SYDNEY CENTRAL CITY PLANNING PANEL

COUNCIL ASSESSMENT REPORT

Panel Reference	2018SWC093
DA Number	DA/1157/2016/A
LGA	City of Parramatta Council
Proposed Development	Section 4.55(2) modification to approved concept plan for 4 stage mixed use development, including increase in number of proposed dwellings from 1,077 to 1,126 (49 additional dwellings), modification to building envelope heights and footprints, realignment of superlot boundaries and street network and revised subdivision plan.
Street Address	657 - 661 Victoria Road & 4 - 6 Wharf Road, MELROSE PARK (Lots 2 & 3 DP588575, Lot 11 DP128907, Lots 1 & 2 DP221045, Lots 71 & 72 DP1136996, Lot 2 DP619396, Lots 1 & 2 DP128912)
Applicant	M Projects Pty Ltd (on behalf of Payce)
Owner	Tyriel Developments Pty Ltd
Date of lodgement	19 July 2018
Number of Submissions	Four (4)
Recommendation	Approval subject to revised conditions
Regional Development Criteria	The proposal is a s4.55(2) modification to an application with a capital investment value of more than \$20 million.

Report date	31 August 2018

Figure 7. Concept Plan as proposed to be modified.

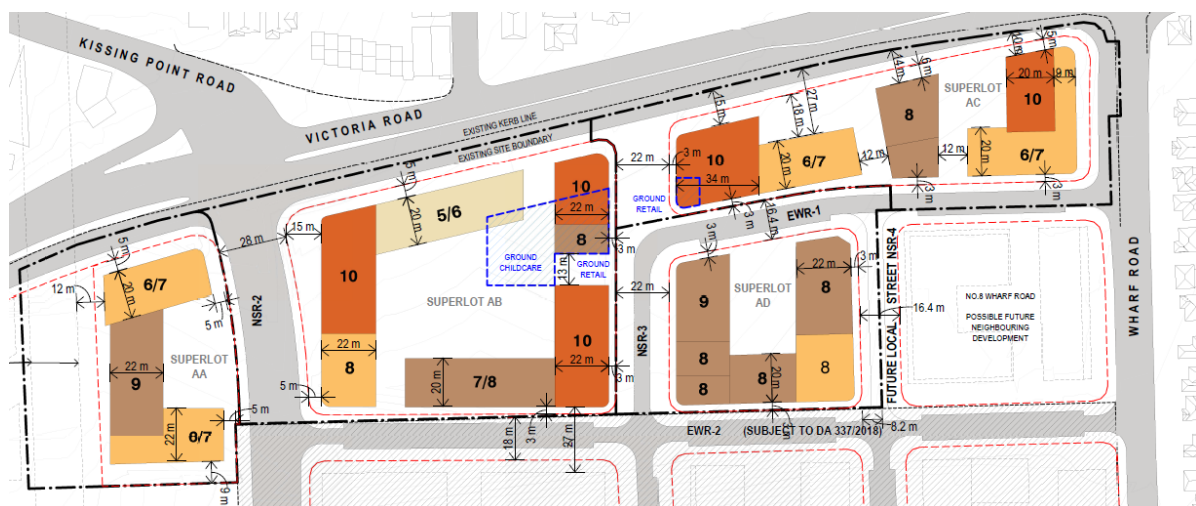
Consent is sought to modify the concept plan as follows:

- Increase in the allowable floor space equivalent to approximately 49 additional dwellings (1,077 to 1,126);
- Modification to building envelope height and footprints;
- Revise the alignment of EWR-2 south in keeping with the approved road (DA/337/2018).
- Realignment of superlot boundaries;
- Delete requirement to widen Wharf Road prior to occupation of Stage 2.
- Defer road and open space dedications to a mutually agreeable time to the applicant and Council.
- Increase in commercial floor space from 767sqm to 1,471sqm.

Urban Design	<p>Urban Design is supportive in principle of the amended layout of the street configuration, which improves connectivity and provides the necessary street frontage for Superlot AD.</p> <p>The current proposal significantly increases the length of non-complying 10 storey buildings on Superlot AB, as well as seemingly increasing the height of 7 and 8 storey buildings on Superlots AB and AD to 8 and 9 storeys. 10 storey buildings should firstly be limited in extent, and also tied to reductions in height elsewhere so as to achieve meaningful variation in height over the precinct. It is considered that the proposal does not satisfy this objective.</p> <p>The incremental height changes proposed with this application, while apparently minor and incidental to the altered street and lot layout, exacerbate a situation already straining to achieve acceptable urban form and amenity.</p> <p>Given the above, the proposal is not supported by Urban Design. The extent of 10 storey building footprint should be limited to that of the approved scheme, and no increase in height (measured from natural ground level to top of buildings) of the approved 7 and 8 storey elements should be contemplated.</p> <p>Refer to Section 6.1.2 below for further discussion.</p>

The above modifications require updates to concept plan conditions 1, 5, 7, 10, 23 and 29 and Stage 1 condition 1. For draft revised working please see Appendix 1.

Figure 8. Building Envelope Height Breaches as approved (28m building height plane in red).

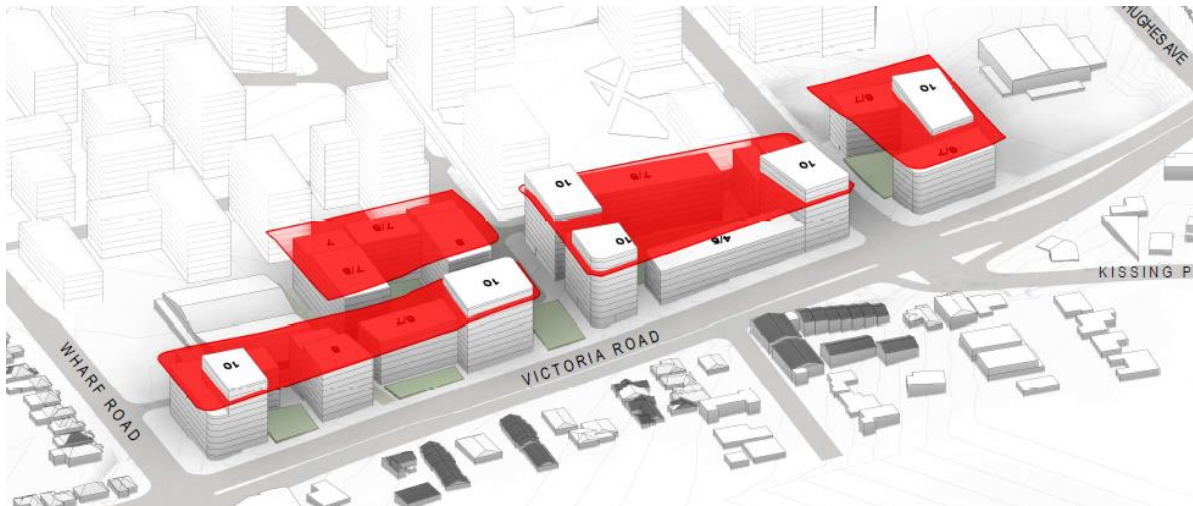
the height limit up to a height of 35m (approx. 10 storeys). The proposal would result in approximately 5,580sqm of footprint which would exceed the height limit up to a height of 35m. This change represents a 7.9% increase. The proposal also includes other minor breaches of the height limits as well as height increases to other envelopes which would remain below the height limit. A comparison of the approved versus proposed breaches is outlined in the figures below.

- While the extent of the breaches are not supported by Council's Urban Design team, the proposal still achieves a discernible variance in height across the site. Complying envelopes may be able to accommodate the floor space but this would result in monotonous and unbroken rows of 8 storey buildings.
- The proposed 10 storey envelopes constitute just 11.7% of the site area.
- The applicant has demonstrated that the revised envelopes do not prejudice the ability of the future applications to provide sufficient deep soil planting and landscaped open space.
- The proposal does not result in any amenity impacts on adjoining or nearby properties and does not prejudice the development potential of any adjoining sites.
- The proposal results in an increase in commercial floor space which is considered to be commendable (see Section 6.17 below).
